Re: Fiesta Subaru 7100 Lomas Blvd. NE
4400 Cutler Ave. NE
Traffic Circulation Layout
Architect's Stamp 4-28-22 (K19-D108A)

Traffic Control Layout Comment Response

TRAFFIC CIRCULATION LAYOUT APPROVED 04/29/2022

SITE PLAN

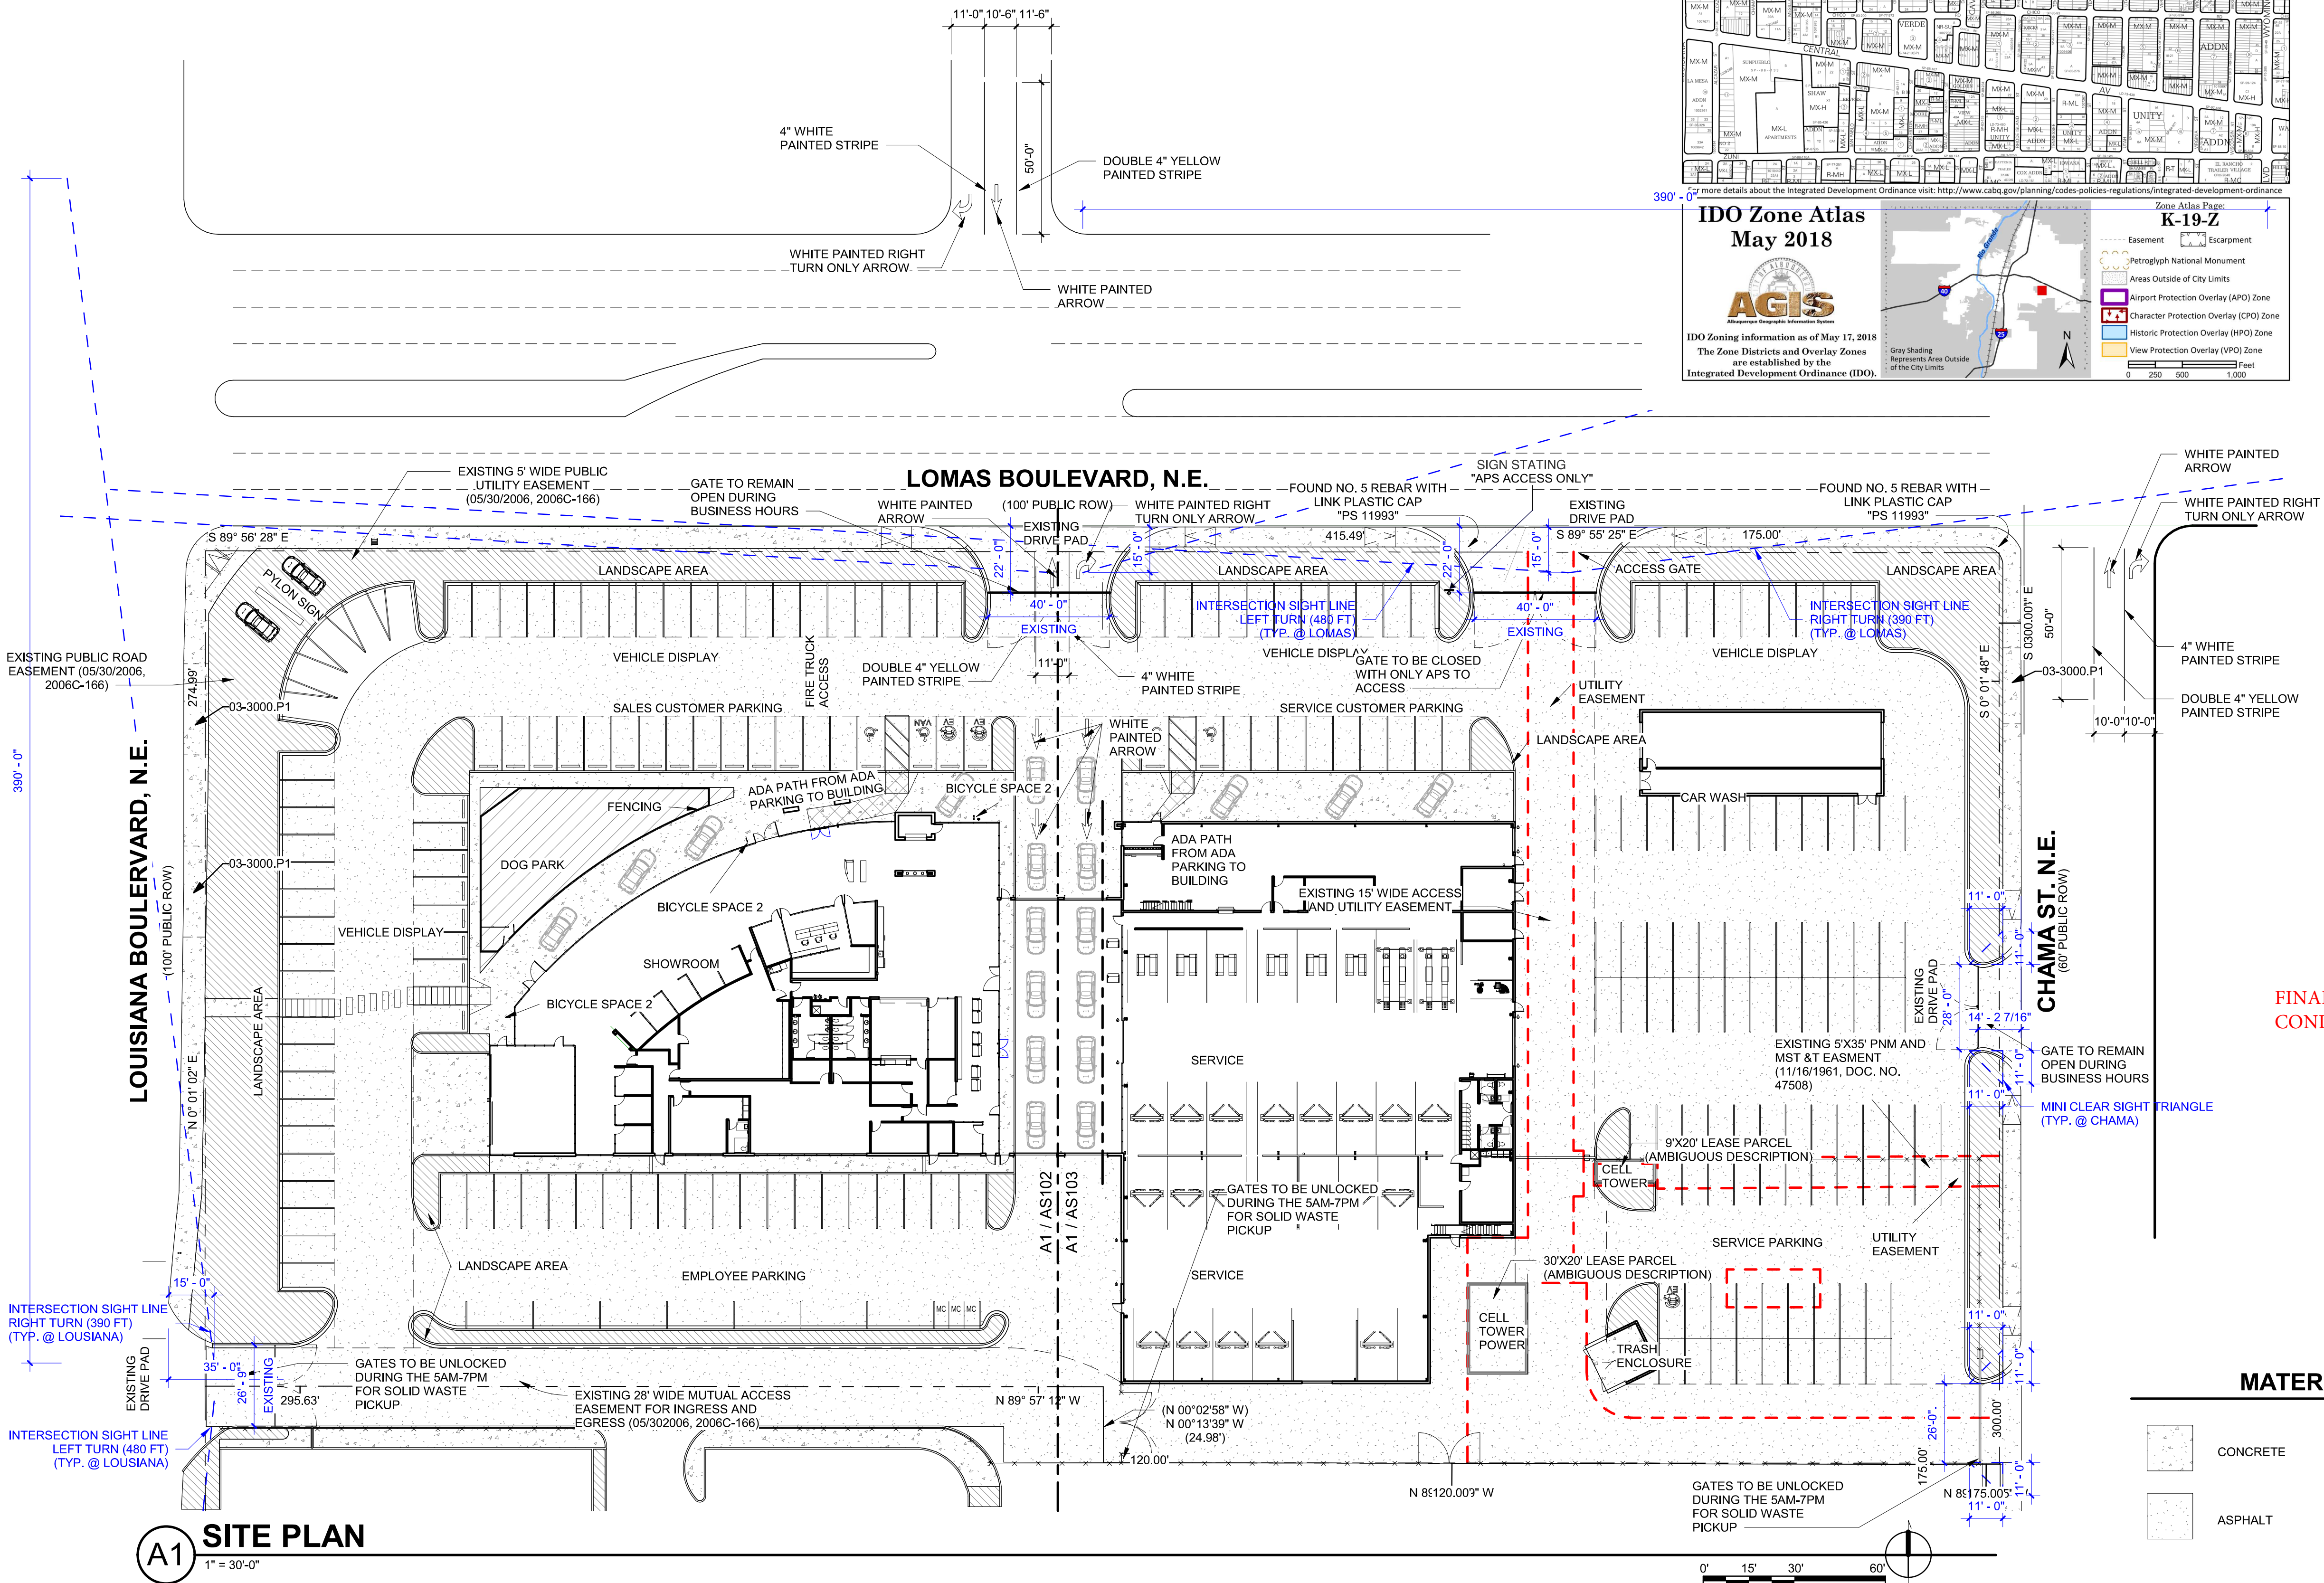
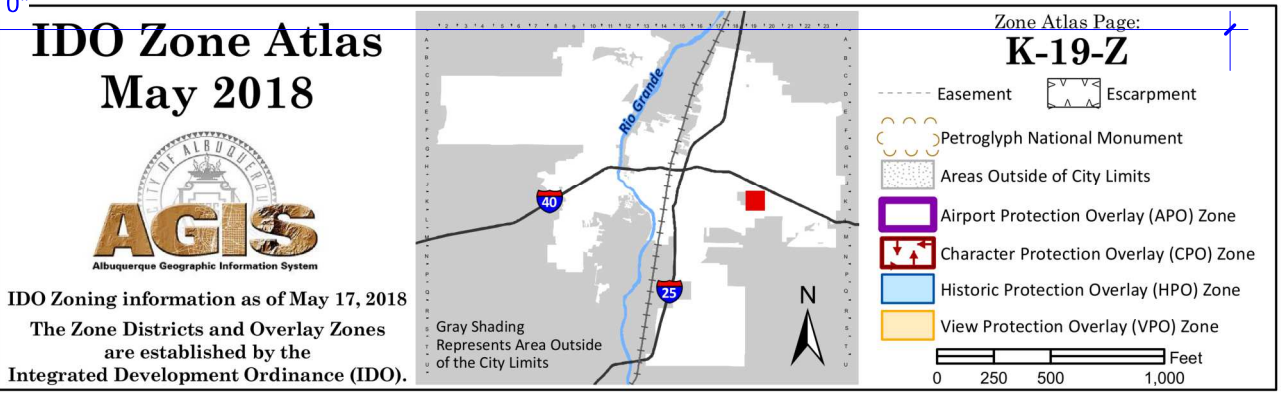
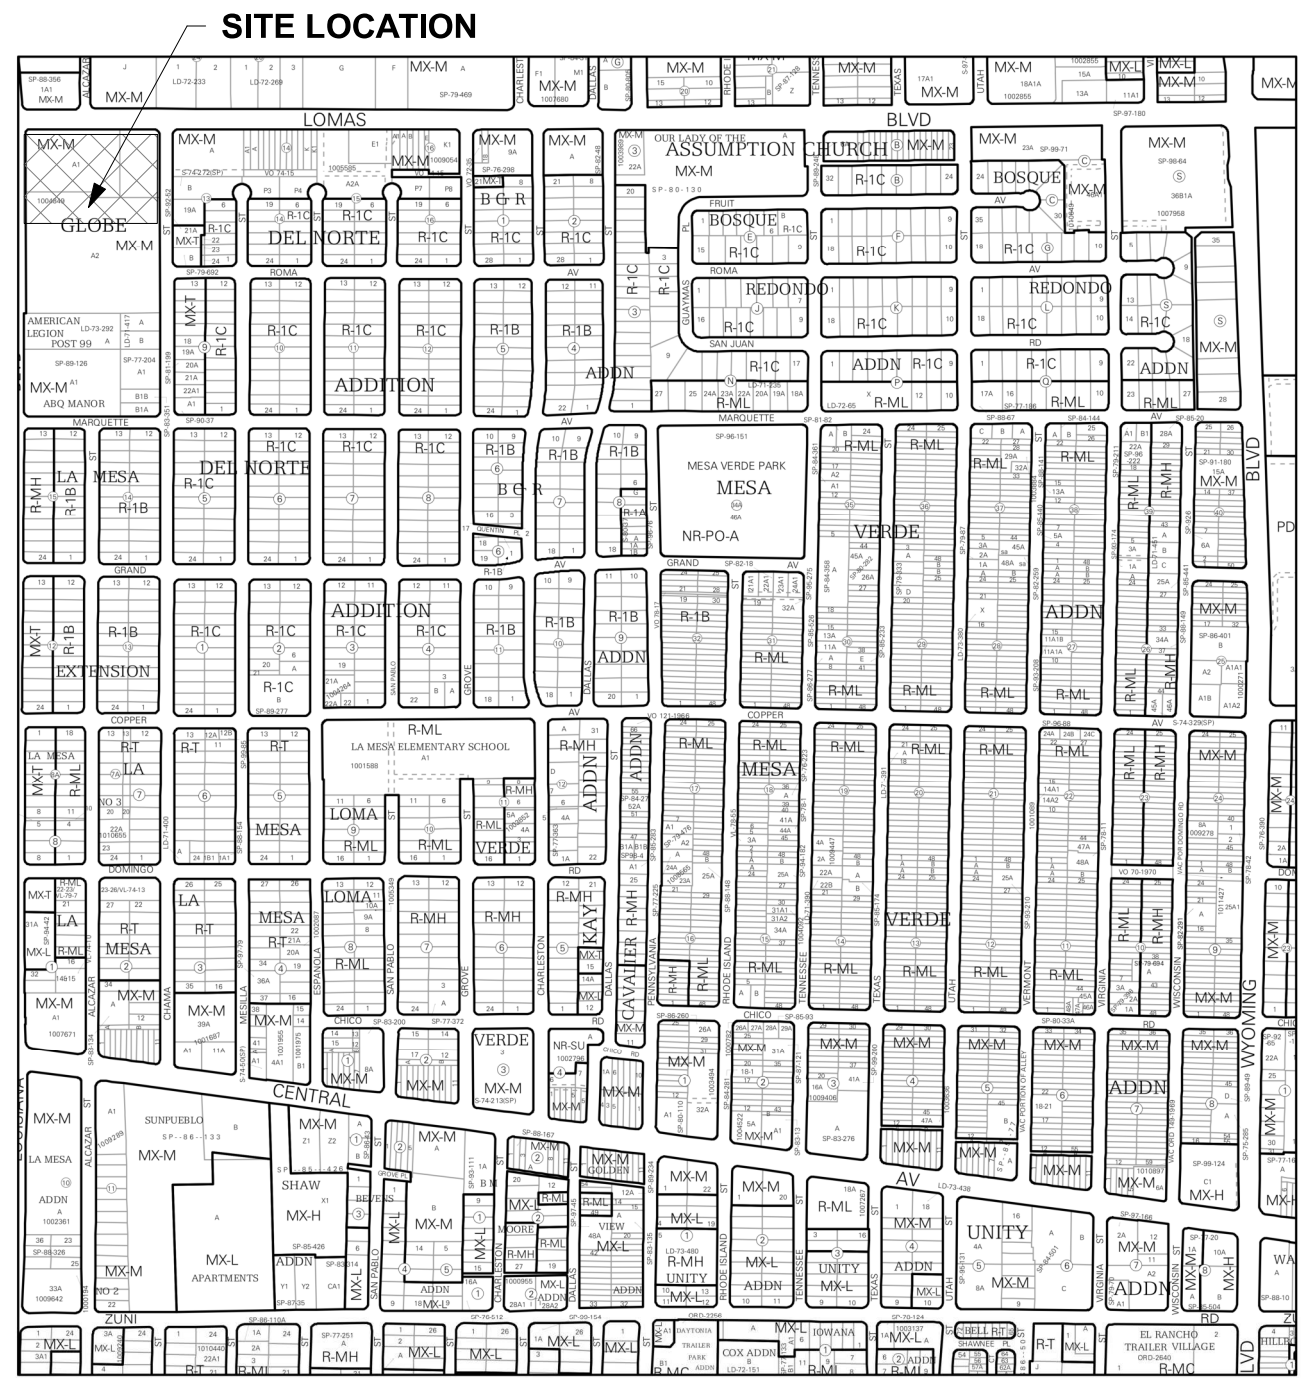
- Sidewalks at corner of Lomas and Louisiana have been changed to have a 48" clearance from the poer pole and the traffic light post
4. All existing drive pads off Louisiana and Lomas are not ADA accessible. So the will need to be ADA accessible and the design will need to be Curb Return since both roadways are classified as Arterial.

- Chama Street label added
6. Identify the right of way width, medians, curb cuts, and street widths on Chamas St. NE
 - See attached Chama ROW PDF
7. Provide details for all proposed pavement markings –

9. Louisiana's, Lomas's and Chama's main access with proposed gates will need a setback of 20 feet to provide turnout.
 - Revised gate design attached.
10. A sidewalk easement will be needed at the corner of Louisiana/Lomas to encompass the full size of new ramp.

22. All sidewalks along public streets need widths provided.
 - Added dimensions to Existing 6'-0" Sidewalks
23. Parking areas shall have barriers to prevent vehicles from extending over onto pedestrian pathway.

- Sight line clearance and note attached
27. Chamas St: Show the clear sight triangle and add the following note to the plan: "Landscaping and signage will not interfere with clear sight requirements. Therefore, signs, walls, trees, and shrubbery between 3 and 8 feet tall (as measured from the gutter pan) will not be acceptable in the clear sight triangle."

- See Attached plat showing this easement
30. Unused curb cuts must be replaced with sidewalk and curb & gutter. A build note must be provided referring to the appropriate City Standard drawing (2430 & 2415A). Two have been identified but not addressed off Louisiana.

- Note added at existing curb cuts on Louisiana to be removed and city sidewalk and curb standard details
31. Add a note stating "All broken or cracked sidewalk must be replaced with sidewalk and curb & gutter." A build note must be provided referring to the appropriate City Standard drawing (2430 & 2415A).

- Note added to replace broken or cracked sidewalks
32. Please provide a letter of response for all comments given.
 - Included
